# UNITED STATES PATENT AND TRADEMARK OFFICE

APPLICATION NO.	FILING DATE	FIRST NAMED INVENTOR	ATTORNEY DOCKET NO.	CONFIRMATION NO.
10/572,752	03/21/2006	Syuuji Nakamura	27304U	3327

<b>Office Action Summary</b>	<b>Application No.</b> 10/572,752	<b>Applicant(s)</b> NAKAMURA ET AL.	
	<b>Examiner</b> Trinh Vo Dinh	<b>Art Unit</b> 2821

### **DETAILED ACTION**

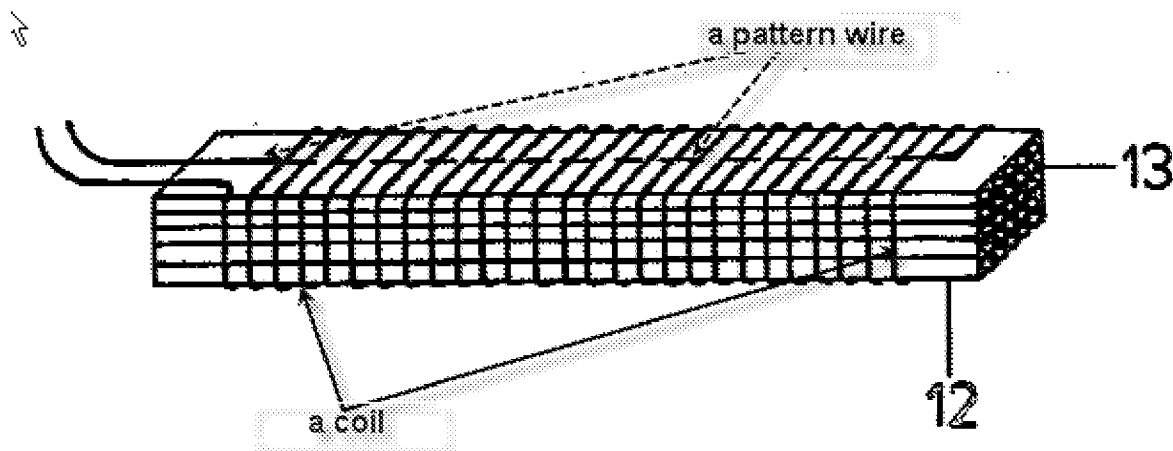
Maruyama does not teach a pattern wire. Hein discloses a pattern wire (in Fig. 3, 6, and 9 or the below drawing) passing through a longitudinal center line of a coil (4 in Fig. 3, or the below drawing). It would have been obvious to one having ordinary skill in the art to wind Maruyama's coil with a pattern wire arranged to pass through a longitudinal center line of the coil as disclosed by Hein in order to avoid adversely affect the electrical and magnetic properties (Hein: [paragraph [0057])). Claim 1 further recites "the pattern wire configured such that linkage with respect to the magnetic flux at the coil is prevented". Hein discloses the same structural configuration as the claimed invention. Therefore, although not explicitly stated in Hein, the pattern wire of Hein would be configured such that linkage with respect to the magnetic flux at the coil is prevented as claimed.
